ADDENDUM NO. TWO

August 19, 2026

**Project Fast
Shelby-Cleveland County Regional Airport
Shelby, North Carolina
WKD Project No. 20231027.00.CL**

PROJECT NAME: PROJECT FAST FOR SHELBY-CLEVELAND COUNTY REGIONAL AIRPORT (EHO) SHELBY, NORTH CAROLINA
DRAWING TITLE: GRADING, DRAINAGE & EROSION CONTROL PLAN

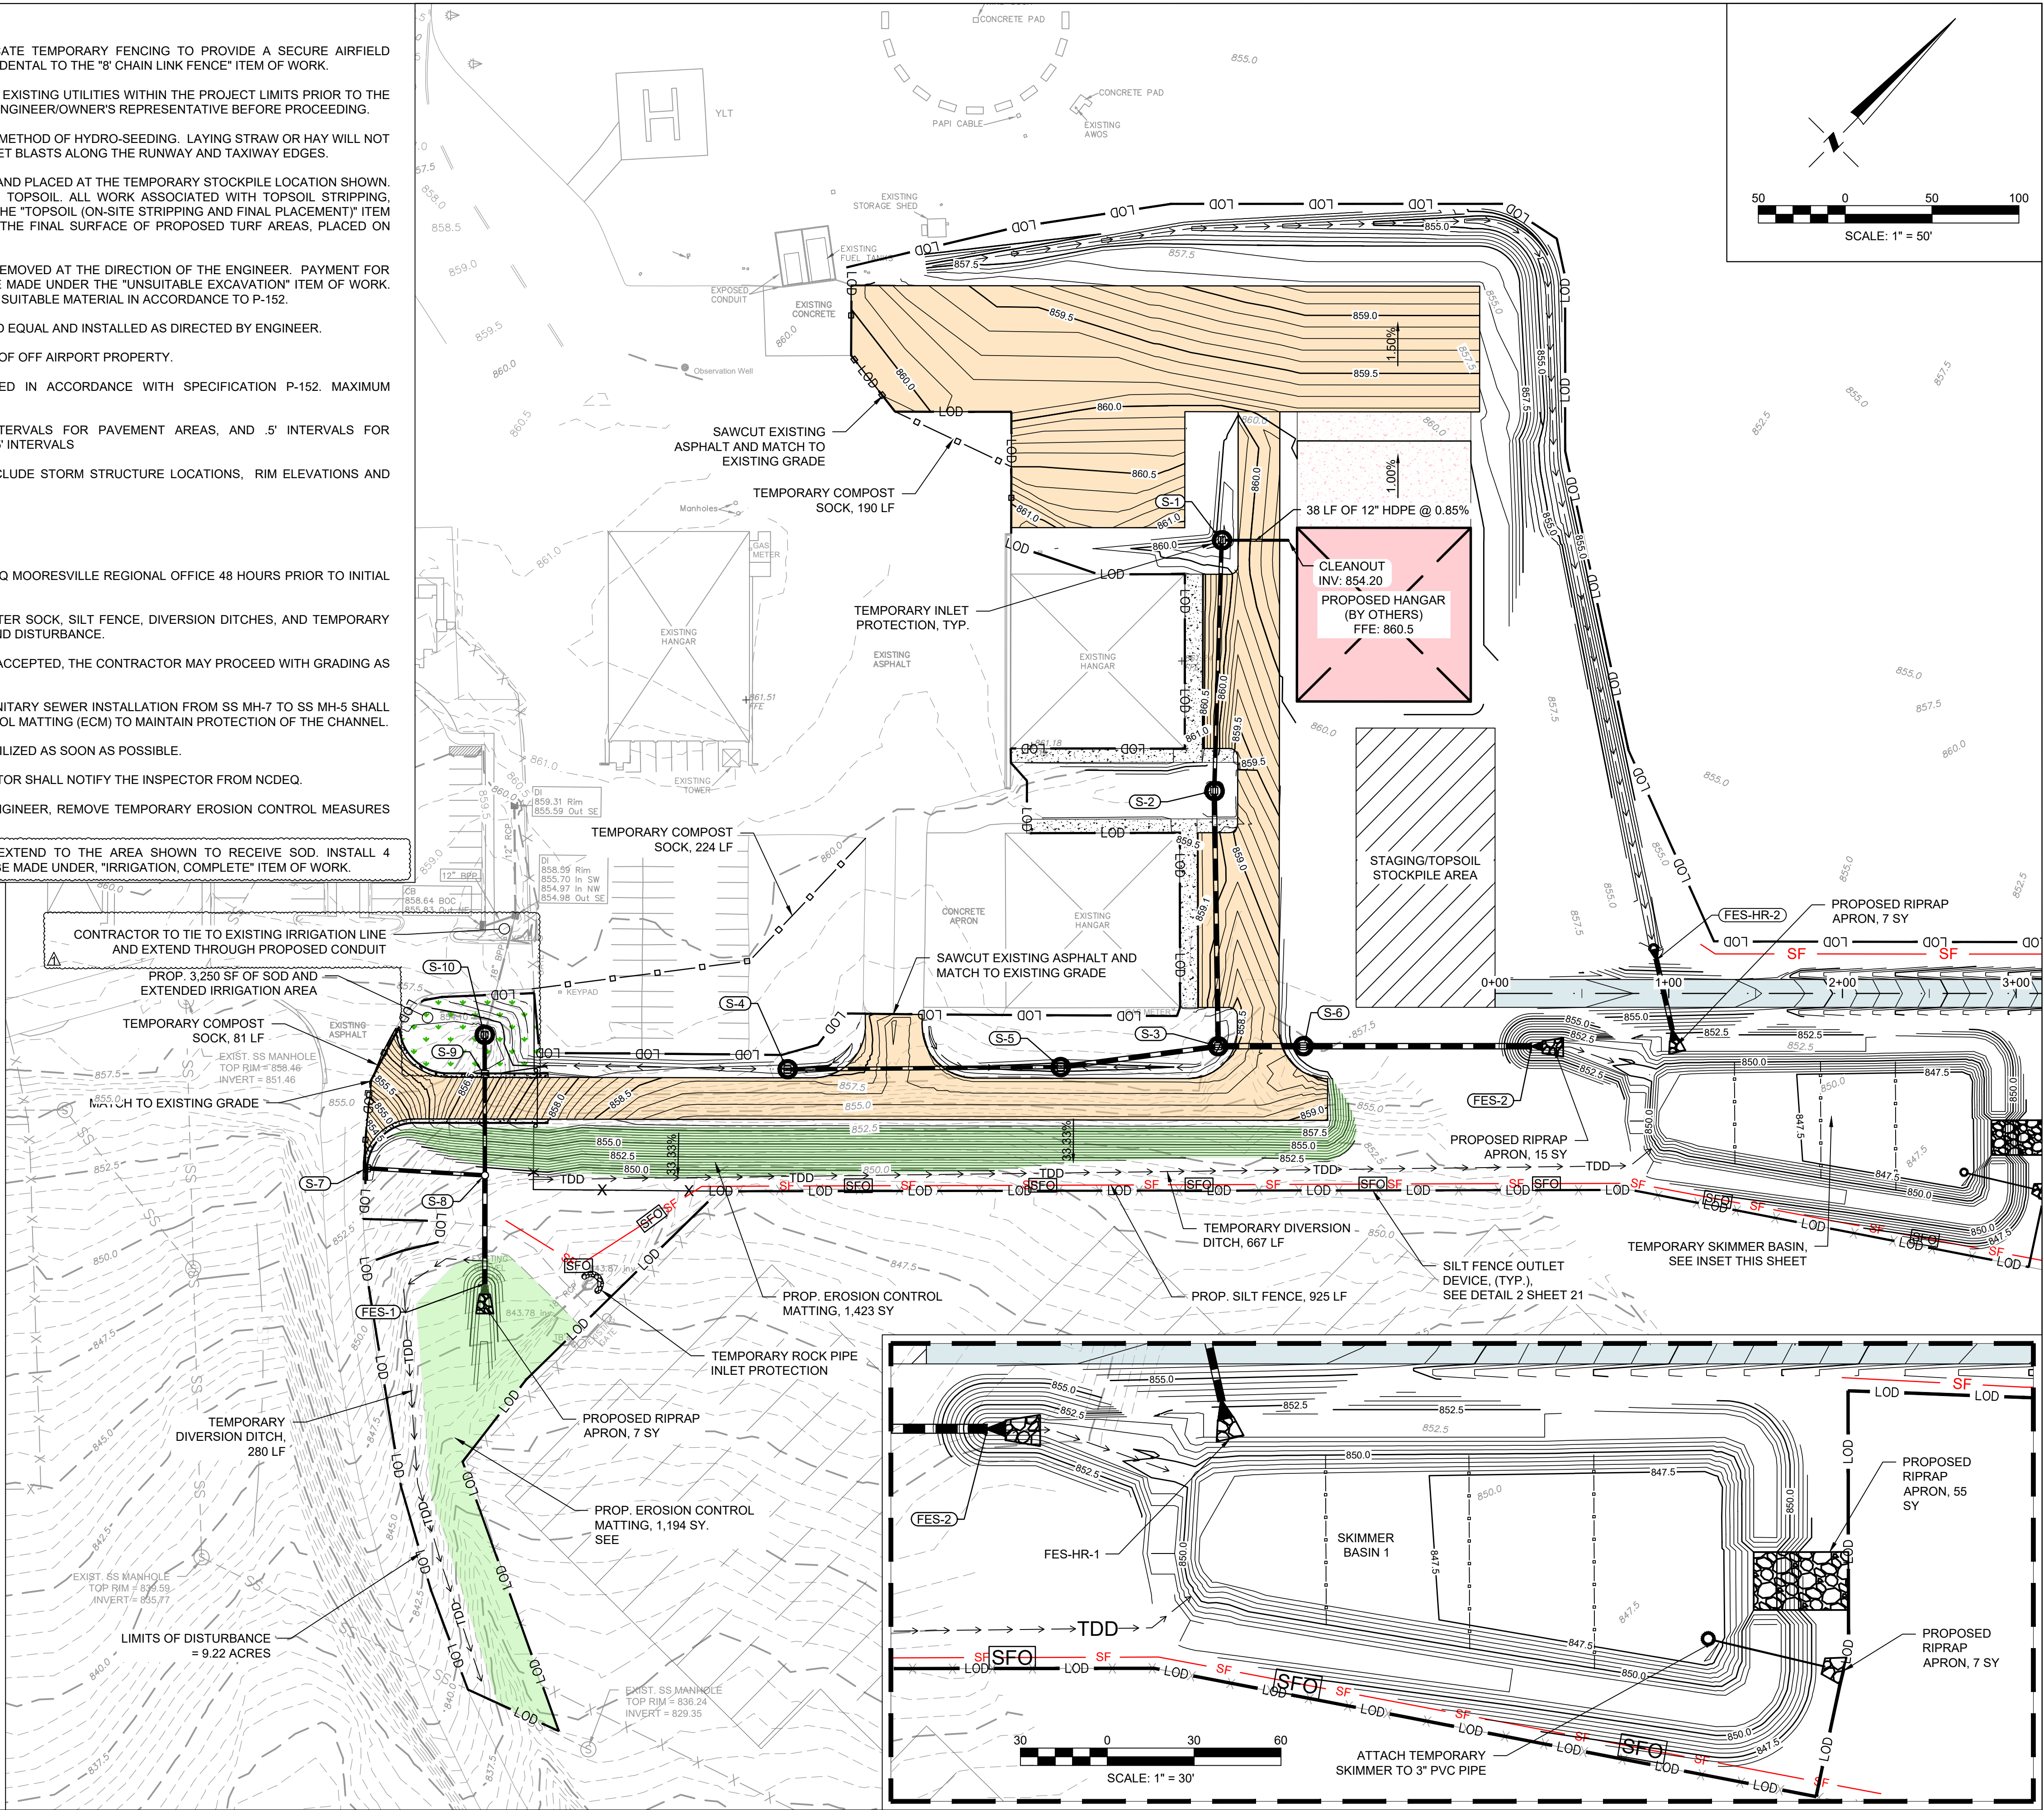
6. A small extension to the existing irrigation system and associated sod installation have been added to the project scope.

8. UPON APPROVAL FROM THE NCDEQ INSPECTOR AND THE ENGINEER, REMOVE TEMPORARY EROSION CONTROL MEASURES AND STABILIZE ANY EXPOSED BARE EARTH.
9. CONTRACTOR SHALL TIE INTO EXISTING IRRIGATION AND EXTEND TO THE AREA SHOWN TO RECEIVE SOD. INSTALL 4 SPRINKLERS IN THIS AREA. PAYMENT FOR IRRIGATION SHALL BE MADE UNDER "IRRIGATION, COMPLETE" ITEM OF WORK.

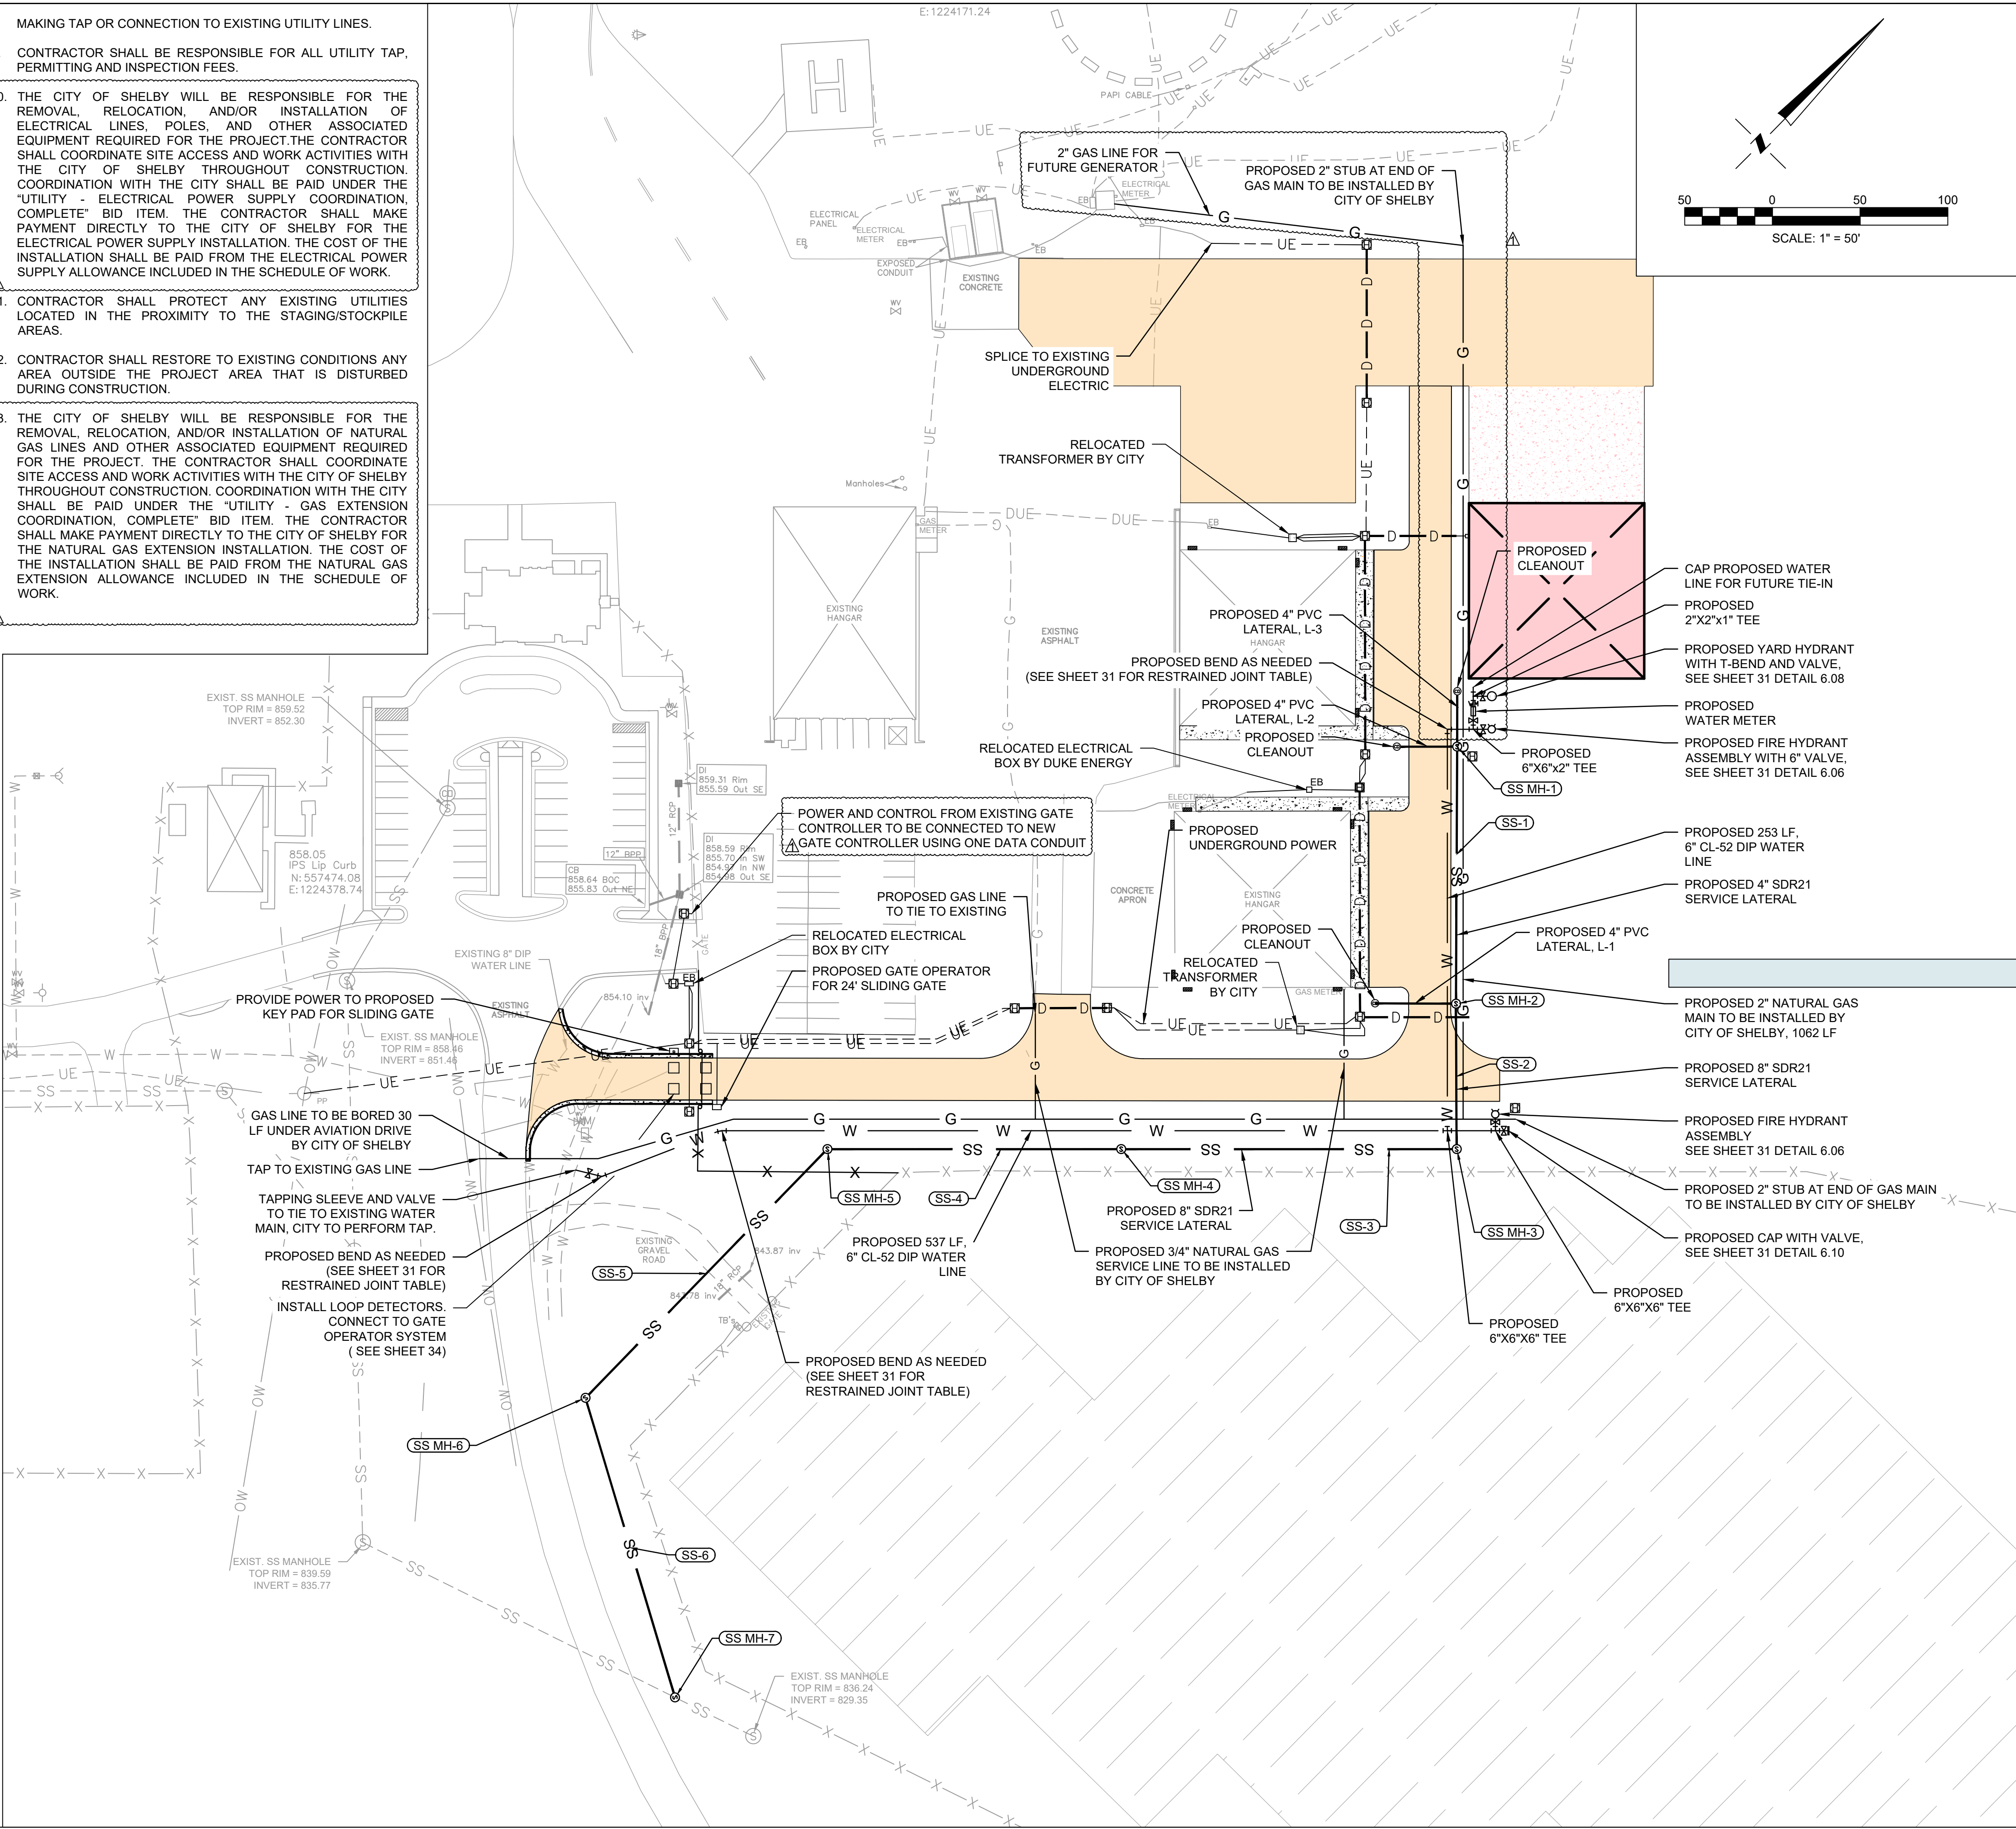
4. Utility note #10, addressing the Contractor's responsibilities related to providing power to the new hangar site, has been revised.
5. Utility note #13, addressing the Contractor's responsibilities related to extending natural gas service to the new hangar site, has been revised.

10. THE CITY OF SHELBY WILL BE RESPONSIBLE FOR THE REMOVAL, RELOCATION, AND/OR INSTALLATION OF ELECTRICAL LINES, POLES, AND OTHER ASSOCIATED EQUIPMENT REQUIRED FOR THE PROJECT. THE CONTRACTOR SHALL COORDINATE SITE ACCESS AND WORK ACTIVITIES WITH THE CITY OF SHELBY THROUGHOUT CONSTRUCTION. COORDINATION WITH THE CITY SHALL BE PAID UNDER THE "UTILITY - ELECTRICAL POWER SUPPLY COORDINATION, COMPLETE" BID ITEM. THE CONTRACTOR SHALL MAKE PAYMENT DIRECTLY TO THE CITY OF SHELBY FOR THE ELECTRICAL POWER SUPPLY INSTALLATION. THE COST OF THE INSTALLATION SHALL BE PAID FROM THE ELECTRICAL POWER SUPPLY ALLOWANCE INCLUDED IN THE SCHEDULE OF WORK.

13. THE CITY OF SHELBY WILL BE RESPONSIBLE FOR THE REMOVAL, RELOCATION, AND/OR INSTALLATION OF NATURAL GAS LINES AND OTHER ASSOCIATED EQUIPMENT REQUIRED FOR THE PROJECT. THE CONTRACTOR SHALL COORDINATE SITE ACCESS AND WORK ACTIVITIES WITH THE CITY OF SHELBY THROUGHOUT CONSTRUCTION. COORDINATION WITH THE CITY SHALL BE PAID UNDER THE "UTILITY - GAS EXTENSION COORDINATION, COMPLETE" BID ITEM. THE CONTRACTOR SHALL MAKE PAYMENT DIRECTLY TO THE CITY OF SHELBY FOR THE NATURAL GAS EXTENSION INSTALLATION. THE COST OF THE INSTALLATION SHALL BE PAID FROM THE NATURAL GAS EXTENSION ALLOWANCE INCLUDED IN THE SCHEDULE OF WORK.

DUCT SECTION
(NON-CONCRETE ENCASED)

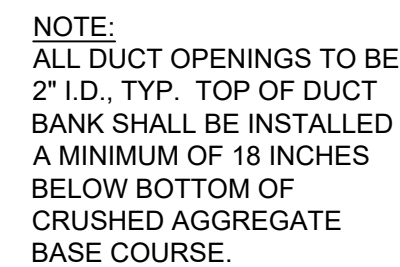
3. 4-Way Duct Bank (Non-Concrete Encased) has been added in non-paved areas to connect the concrete-encased duct banks beneath the proposed pavement. The conduits will be used for future communication lines.

5 POLYMER CONCRETE BOX PLAN DETAIL (HAND HOLE)
NOT TO SCALE

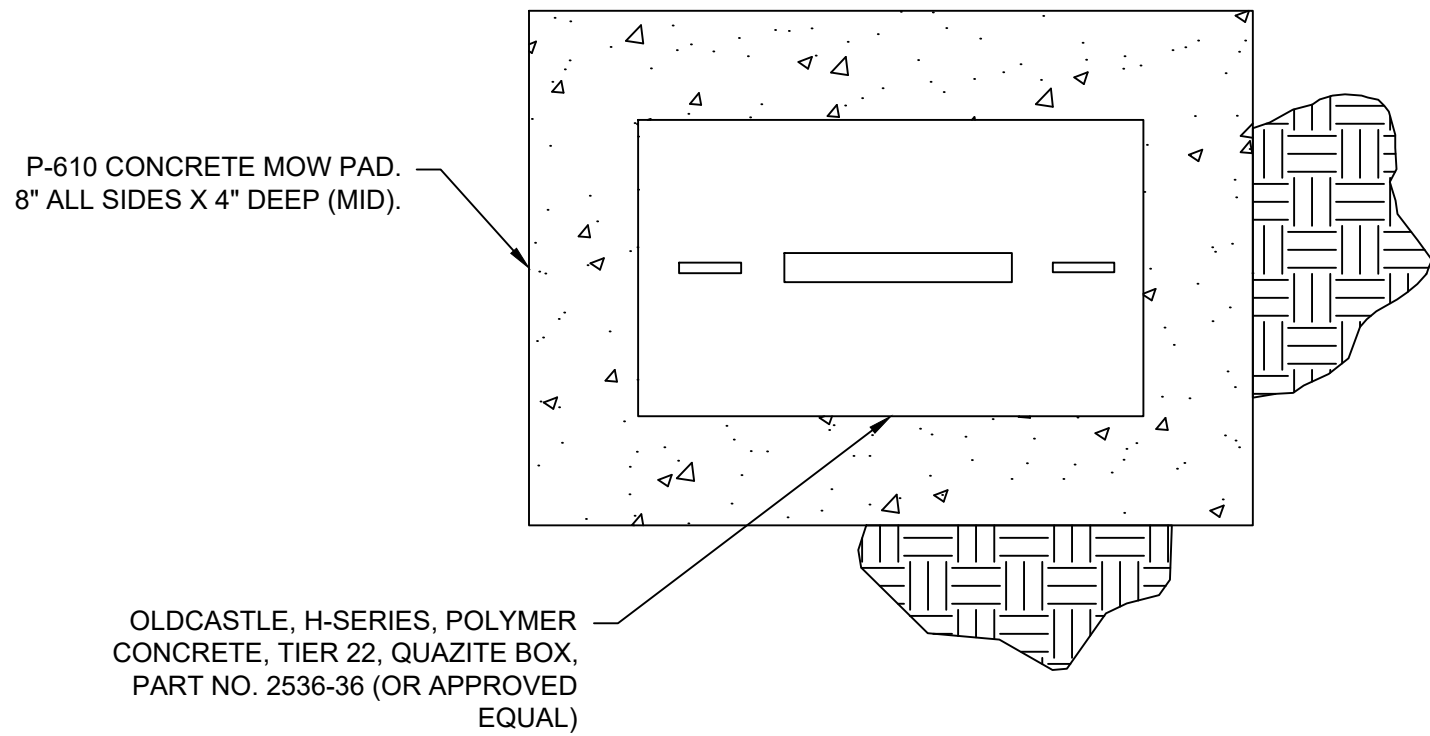
- Item #31 is new: Electrical Hand Hole per EA
 - Item #57 is re-named to: Utility - Electrical Power Supply Coordination, Complete per LS
 - Item #58 is new: Utility - Electrical Power Supply Installation, Complete per ALW
